6756B County Permit Review Worksheet 1373

IMPROVEMENT PERMIT for a RESIDENTIAL ON-SITE WASTEWATER TREATMENT & DISPOSAL SYSTEM

GWS Septic System Design Review

RE: Request for an Improvement Permit for Lot 18 off of Sample Road.
MCHD File #6756B

Scale: 1 inch equals 50 feet	S&ME	Faison - Sample Road LLC	FIGURE
Drawn by: JBP		Lot 18	1
Reviewed by: TCJ		Mecklenburg County, NC	
Date: June, 2007	ENVIRONMENTAL SERVICES · ENGINEERING · TESTING	S&ME Project #1588-05-091

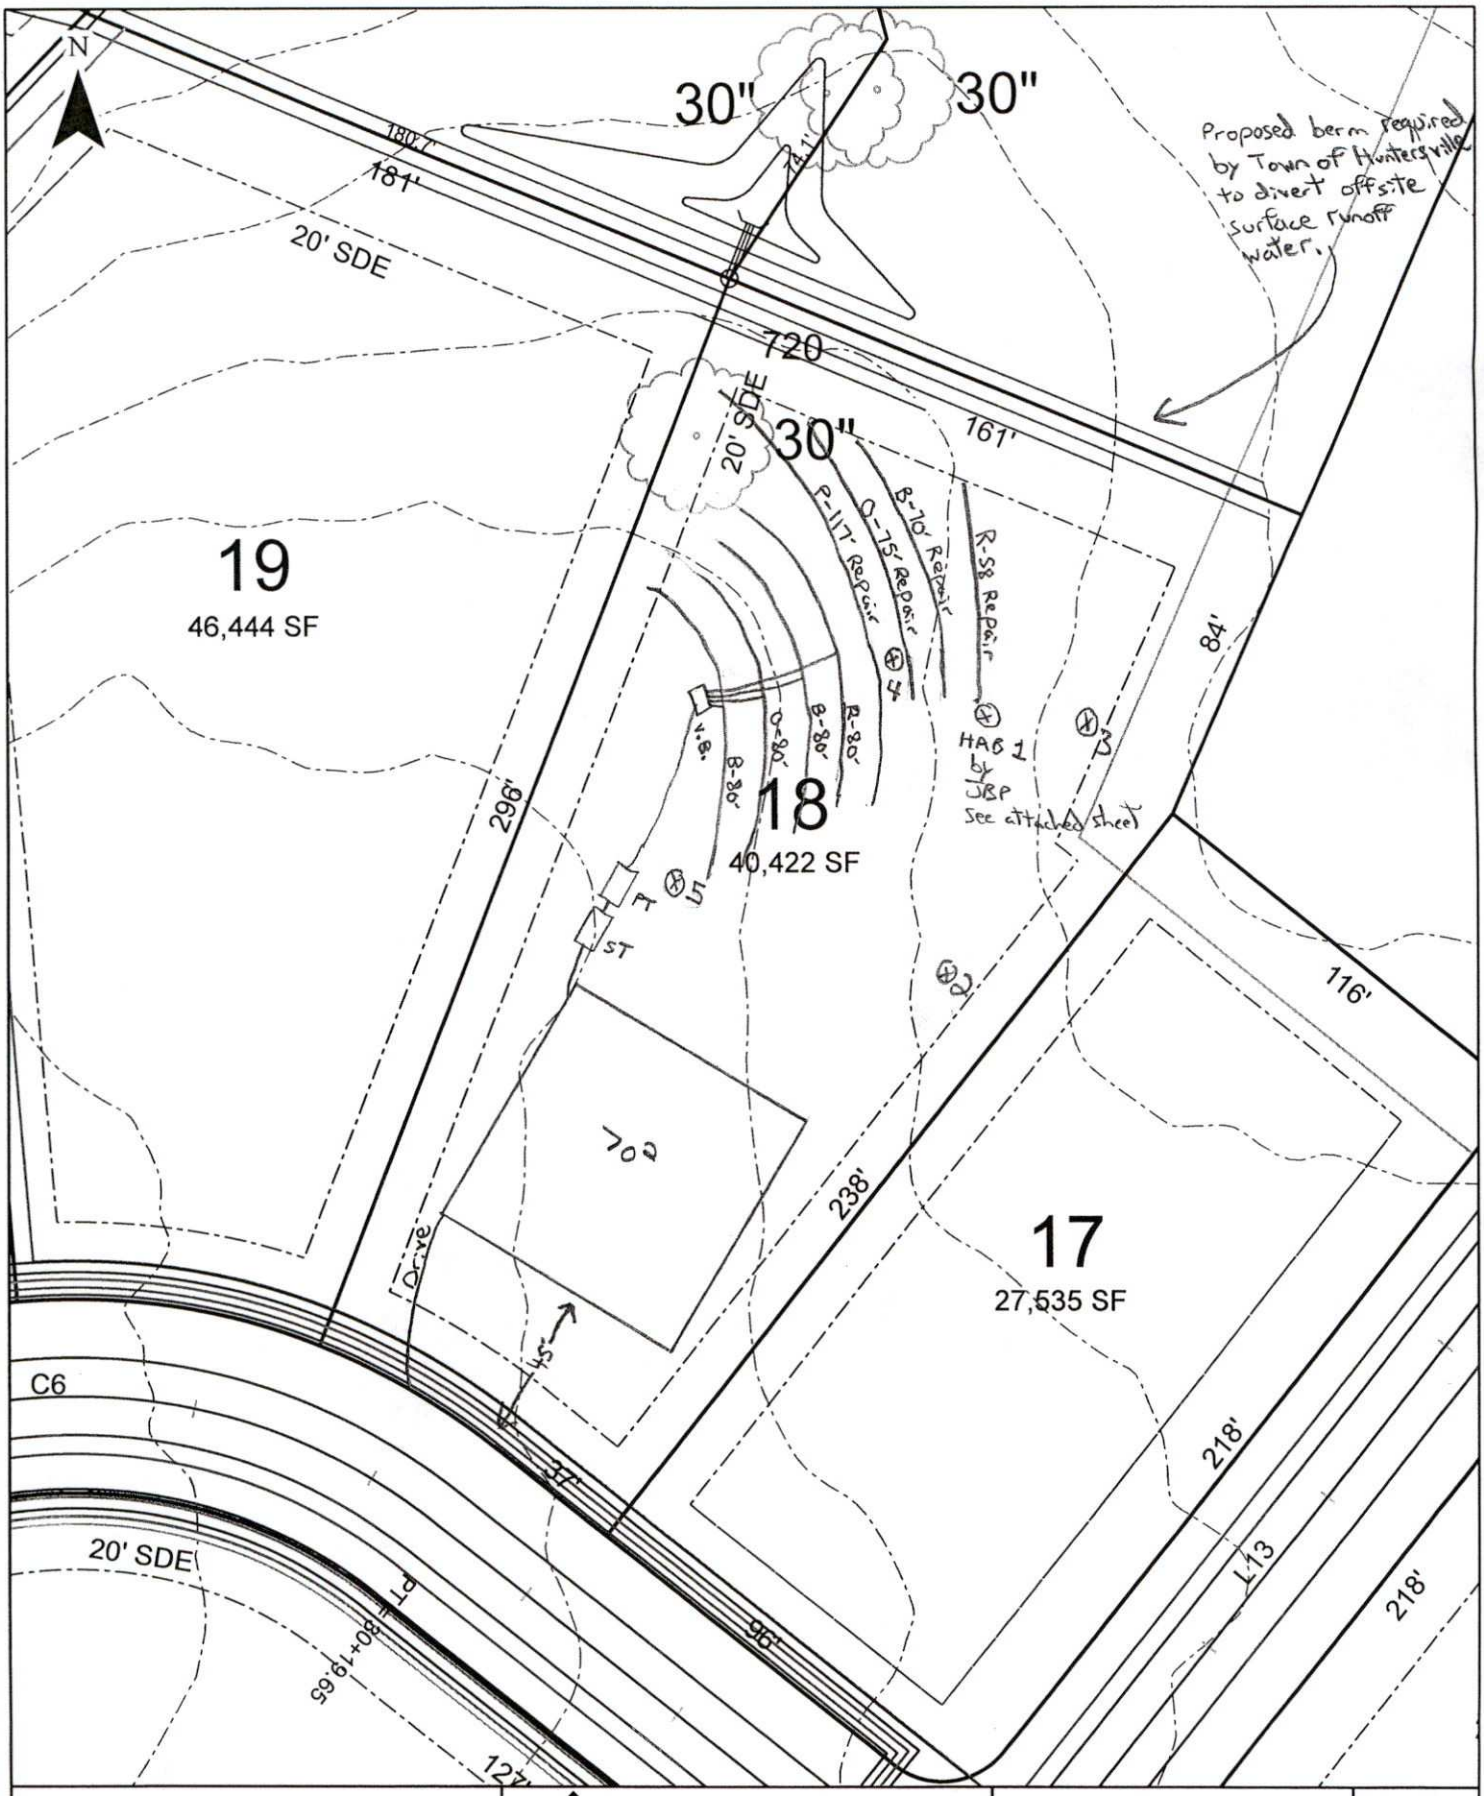
GWS File #: 6756B	Approved	Disapproved
Design Review: TCT 6-13-07	☒	☐
Field Review: 6/14/07	☒	☐

The proposed system is a TYPE IV and will require a contract with a Certified Operator to supply maintenance services for the septic system. Please review the attached system sketch and design specifications for the Improvement Permit. If necessary, the MCHD may add comments to the site plan or specifications. Please call if you have any questions or comments.
